From: Tony Sprckett, Spring Ridge Co-op Housing Assn.
Sent: November 15, 2024 1:11 PM
To: Legislative Services email
Subject: CONCERNS: RE Zoning Reg Bylaw, Amendment (No. 1347), No. 24-071
Attachments: 1276GladstoneAvePublicFeedback.pdf

Re: rezoning and development proposal for 1276 Gladstone Avenue

Folder #: CLC00414

Introduction

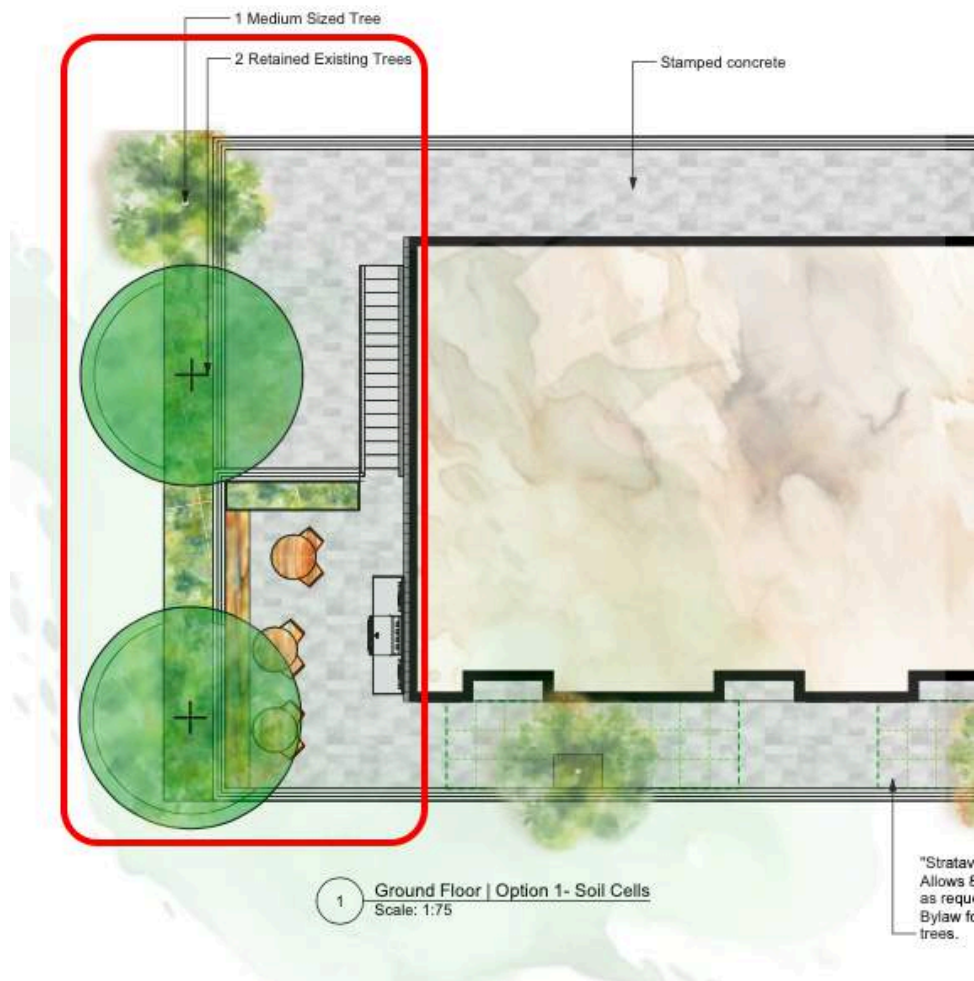
The first appeal noted that page 31 of the first submitted design plan indicates the retention of existing hazelnut trees, suggesting that these trees are part of the development property, as seen in the following image:

As mentioned in the first appeal, these trees shown in the design are not on the 1276 Gladstone property: they are on the other side of the 1275 Pembroke property, as can be seen in the following image:

The first appeal noted concerns the building's foundations would affect the roots of these hazelnut trees. The revised design threatens these trees all the more. The concrete walls proposed for the north end of the 1276 Gladstone property will require digging down to hardpan in order to be engineering compliant—as a result of this digging, the roots of the hazelnut trees will be irreparably damaged and the trees will likely die.

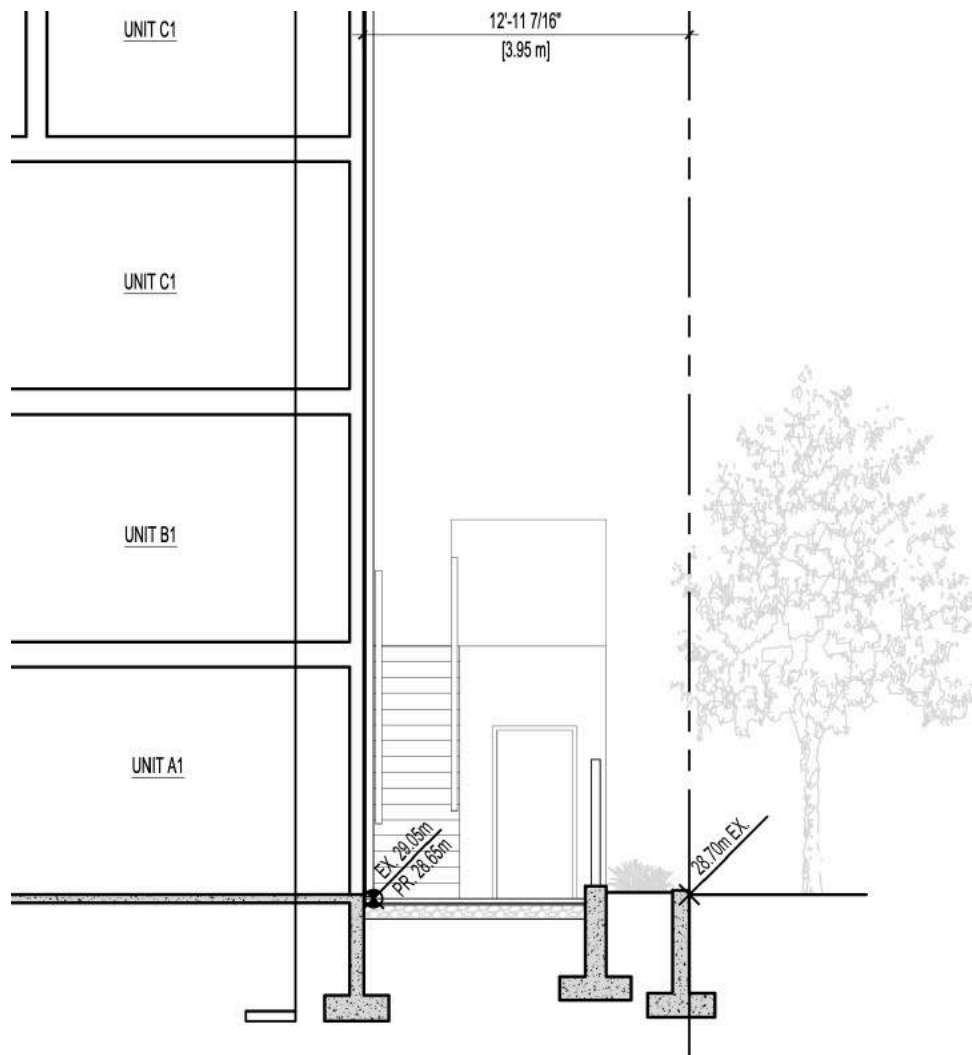
Looking at the architectural drawings, note the proximity of the retaining wall and footings to the symbolic hazelnut tree in the following image:

This rendering is concerning, also, because it misrepresents the scale of the trees (there are two, not just one) and their proximity to the northern property line. This is easy enough to correct for with an image of the architectural depiction:

Aproximate tree height line relative to proposed apartment building

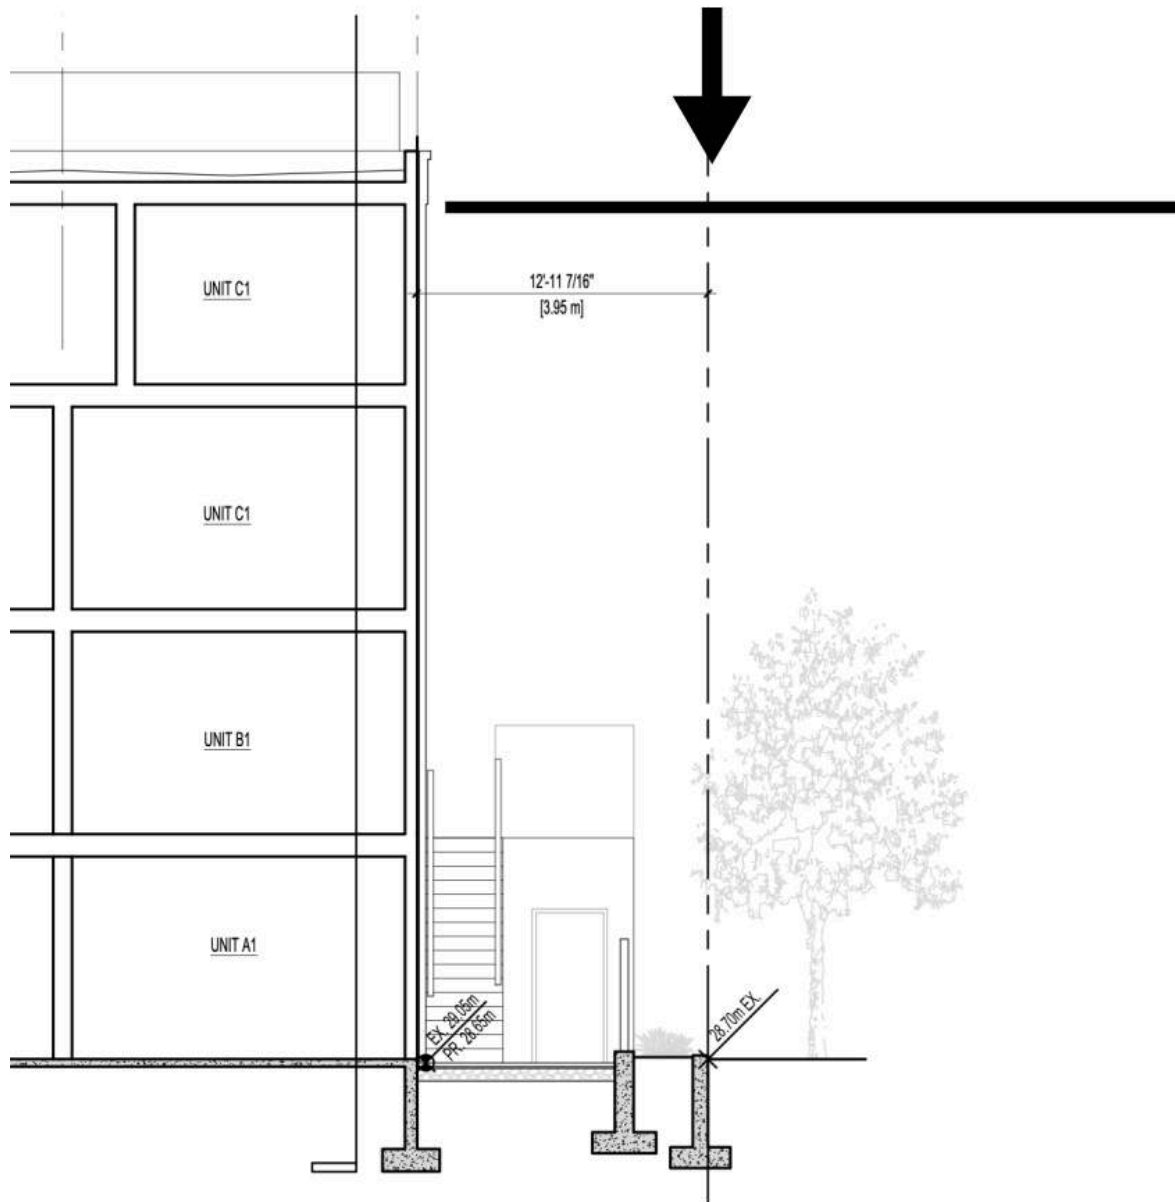
Height-adjusted, the hazelnut tree reaches roughly the fourth floor of the proposed apartment building:

From looking more closely at the site, it appears that it is not possible to build the retaining walls without disturbing the tree roots and ultimately destroying these trees. These trees are a living and thriving community asset, and so another arborist's report should be undertaken in light of the design changes.

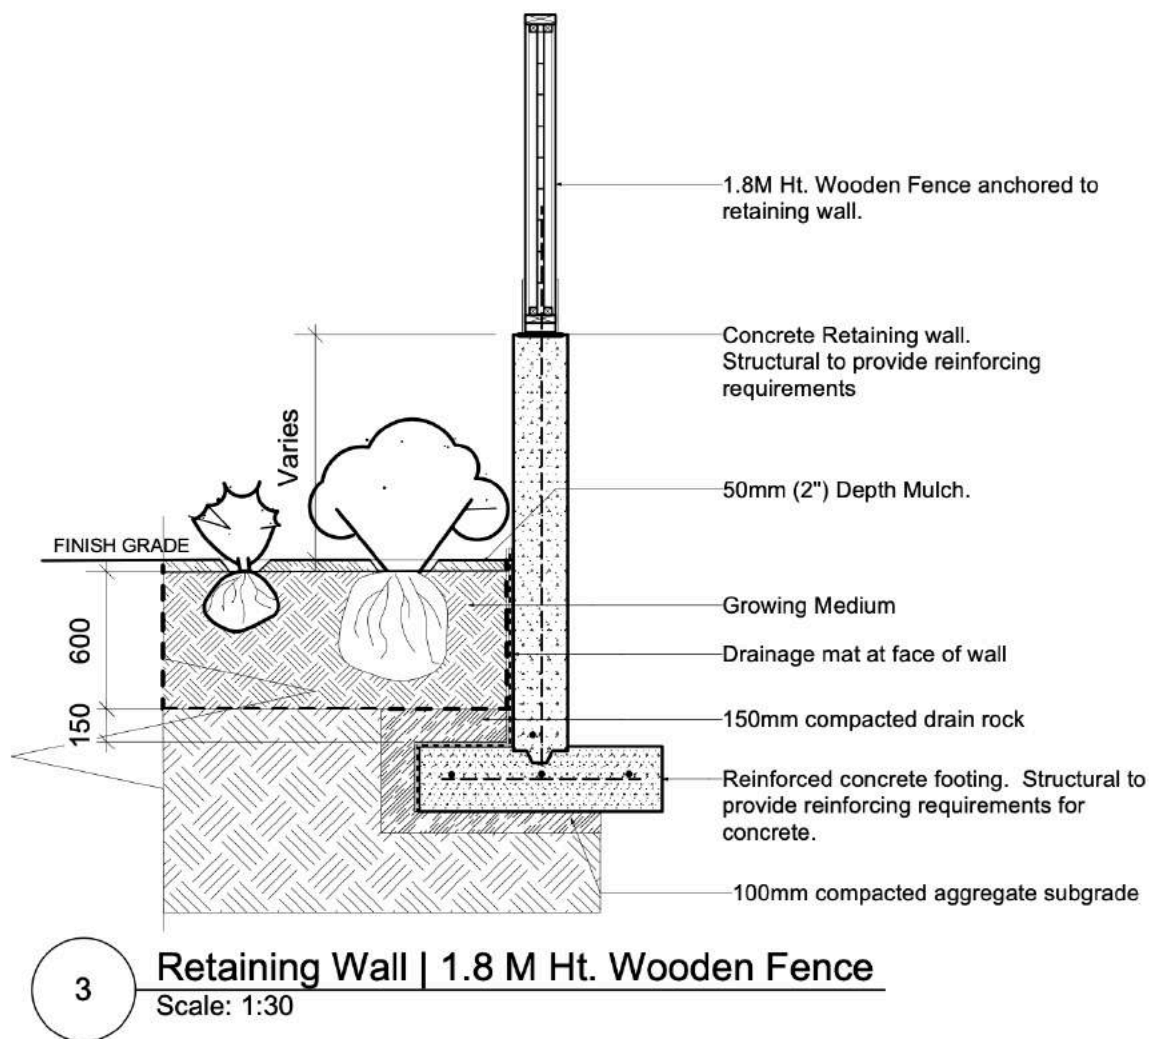
Page 20 of 2023-12-13 - Plans_Revisions.pdf indicates a "1.8 m Ht. Cedar Privacy Fence" along the east edge of the property line. This same page shows a design schematic that includes a retaining wall, to which the cedar fence is affixed.

What the plans fail to show is that the eastern run of the property line already has a partial retaining wall and an existing fence, along with California Lilac hedges grown from seedlings over that last four years.

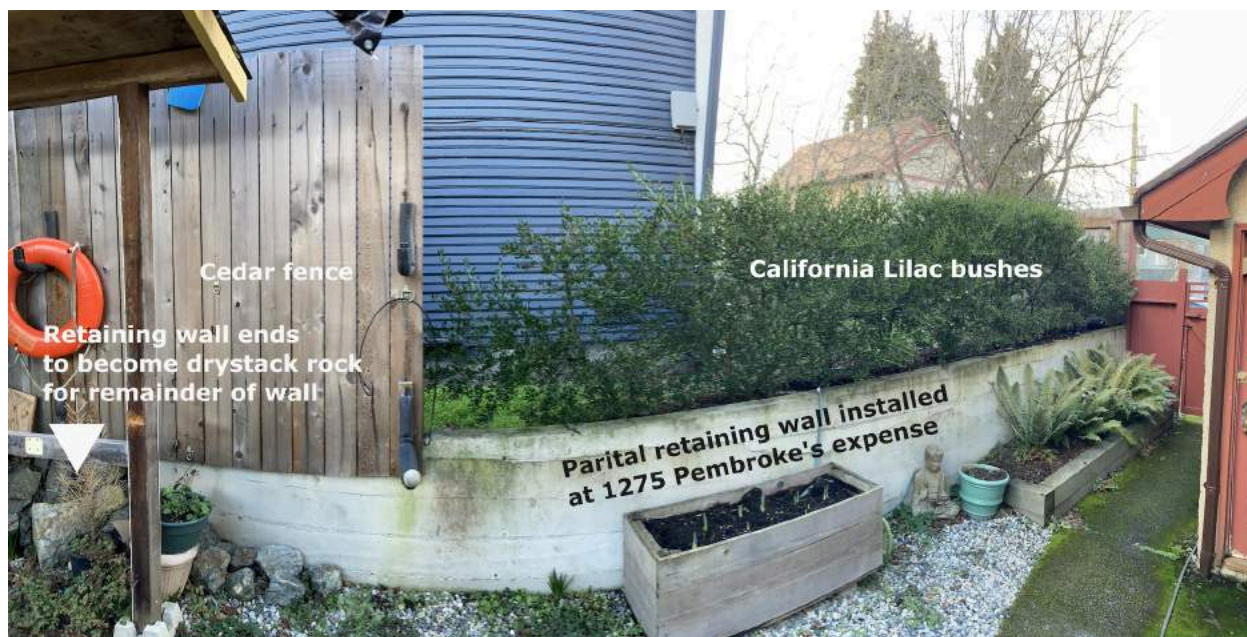
Here is an image of what the eastern run of the property looks like from above:

Neither the developers' plans nor the letter to Council indicate what will happen to existing infrastructure. The Spring Ridge Co-op (at unit 4, 1275 Pembroke) paid for this wall to be installed and would need to be consulted were any changes to occur, especially given the destructive nature of the construction required to install a footed retaining wall and fence along the eastern property line of 1276 Gladstone.
